# Eldorado Springs at Cheyenne Mountain Fil. No. 1

## ADMINISTRATIVE SITE DEVELOPMENT PLAN - SITE LIGHTING PLAN

MAY, 2019

PHOTOMETRIC SITE PLAN  
SCALE: 1"=50'

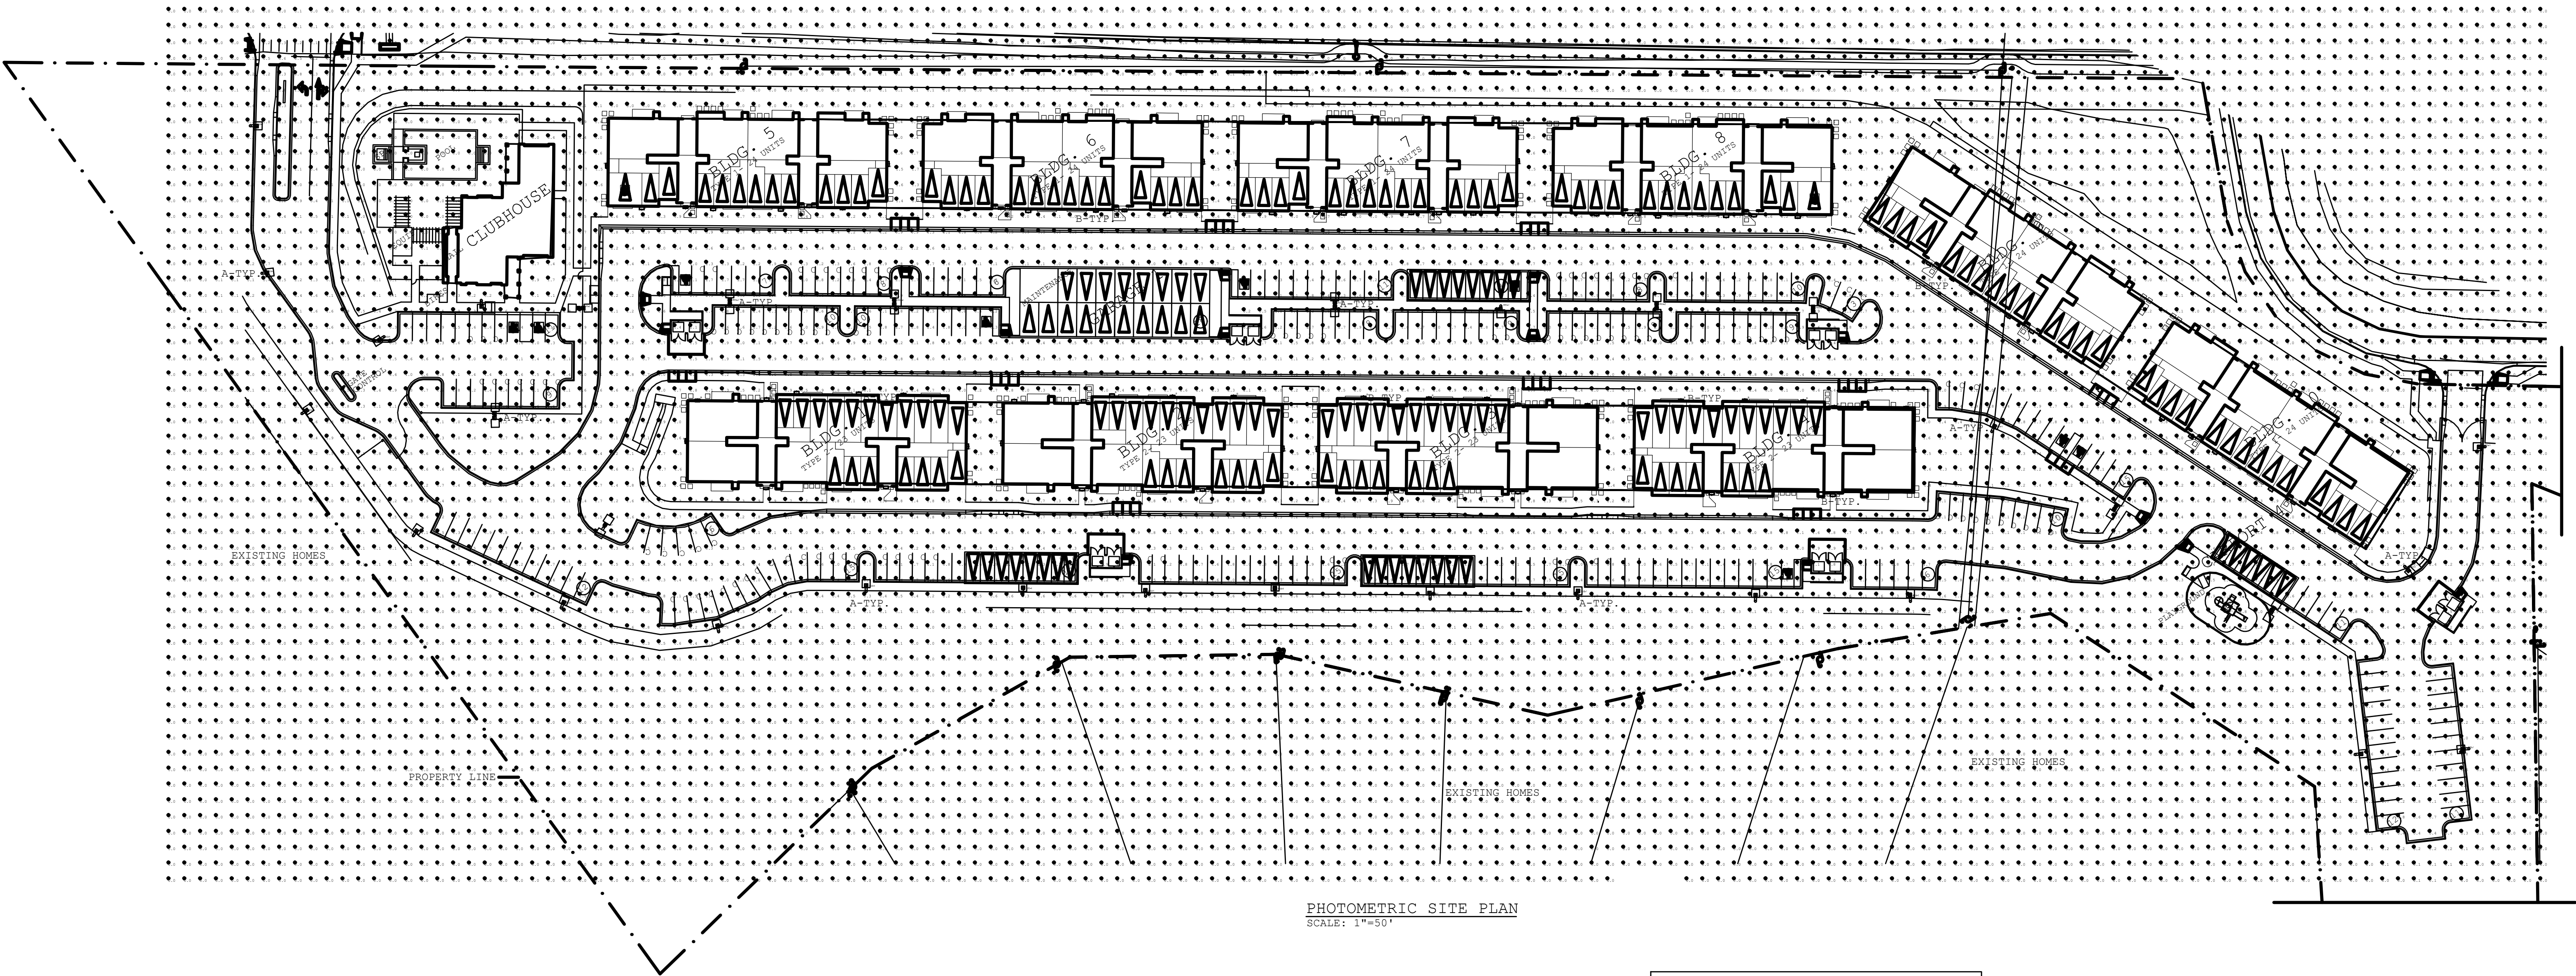
update, needs to be  
INDEPENDENCE  
PLACE AT  
CHEYENNE  
MOUNTAIN FIL NO 1
